APPENDIX 7. INVESTIGATIONS – CIVIL ENGINEERING

Preliminary Infrastructure Assessment

**550-554 Main North Road, Evanston
Park Code Amendment**

JOB NUMBER:	S55577 - 276553
CLIENT:	Future Urban Pty Ltd
SITE:	550-554 Main North Road, Evanston Park
DATE:	20/01/2023
REVISION:	F

Figure 3.4 Predicted inundation during 1% AEP event (long term development scenario) at First Street

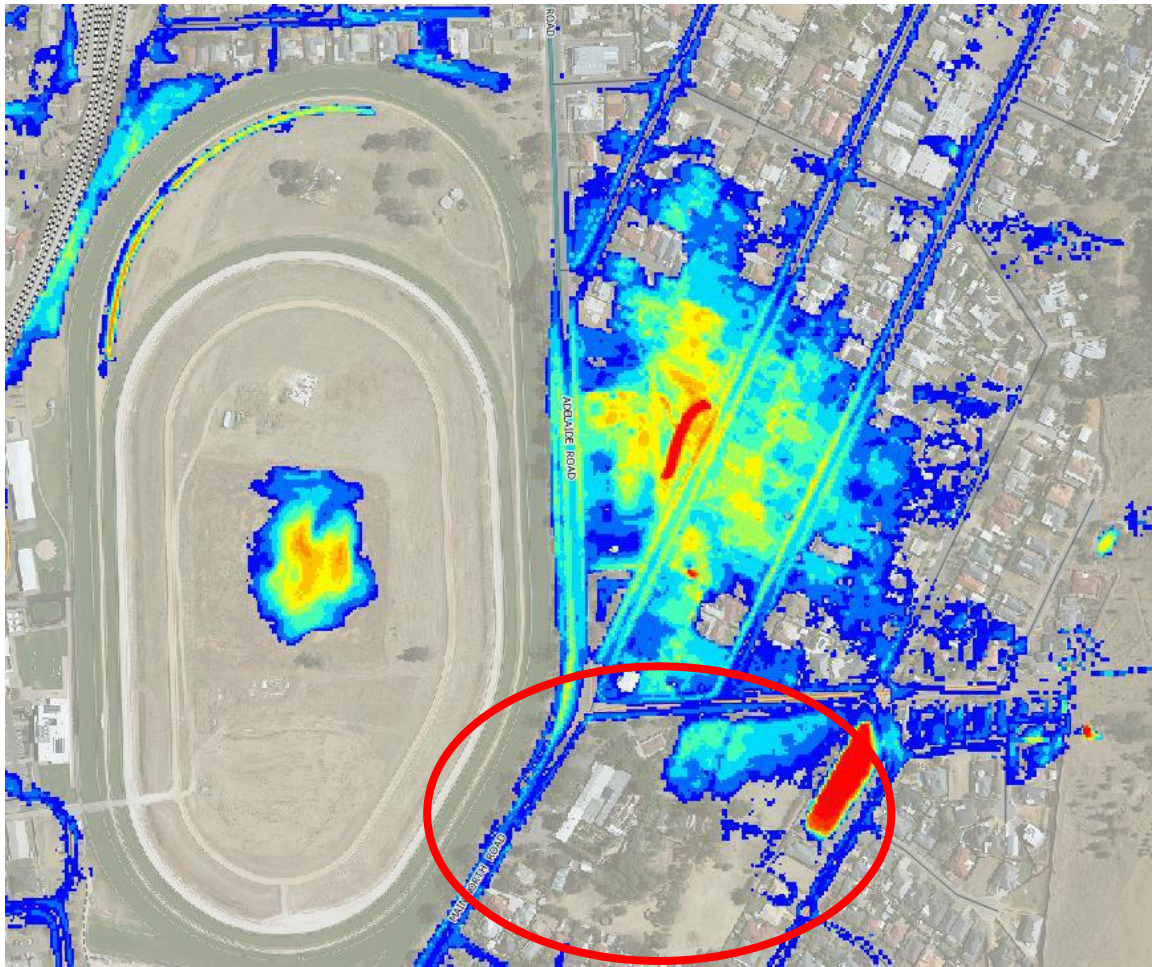
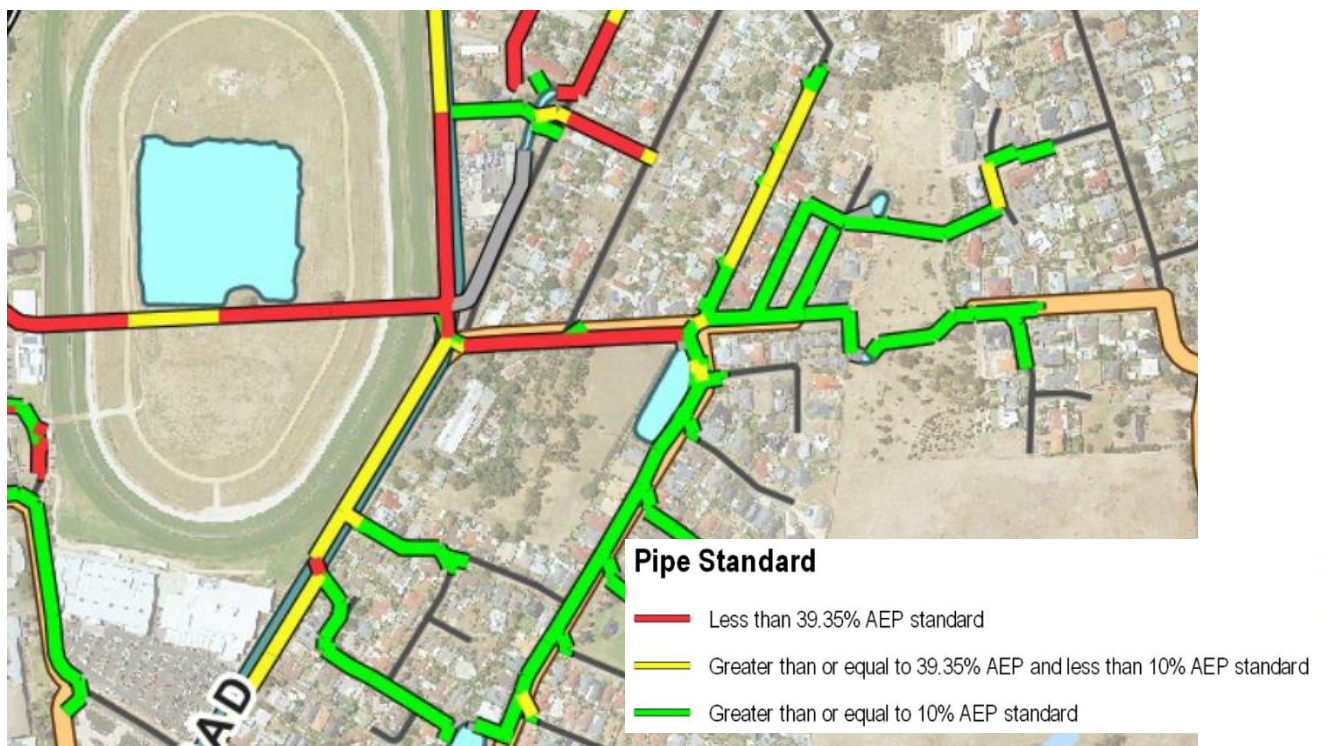
P10 Flood Hazard Overlay

The commentary on the reason for site flooding is flawed. Comments that Council infrastructure is “undersized” seems strange – it is a 1% AEP flood map, Council infrastructure is not designed for a 1% AEP event. Some flooding should be expected. Prefer the Gawler SMP be referred to order to understand why there is flooding here, Council has highlighted the key item in bold:

This site is on the fringe / partly within the flood plain described above. A development proposing a high impervious site coverage needs to be very carefully considered here, both with respect to protection of the development itself, and ensuring that the development does not exacerbate risk to adjoining land.

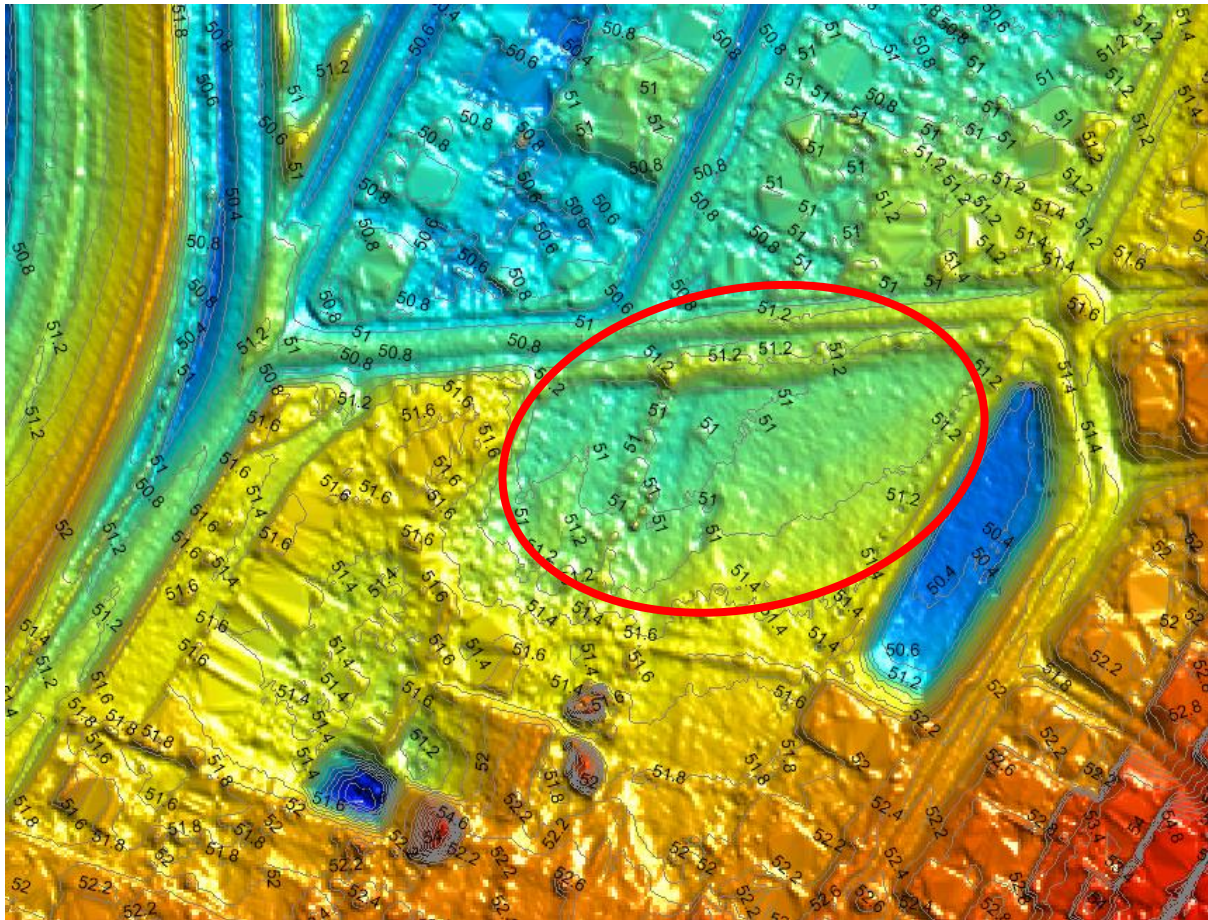
“Filling” of this low lying area will need to carefully assess whether this will lead to increases in flood risk to adjoining northern floodplain area.
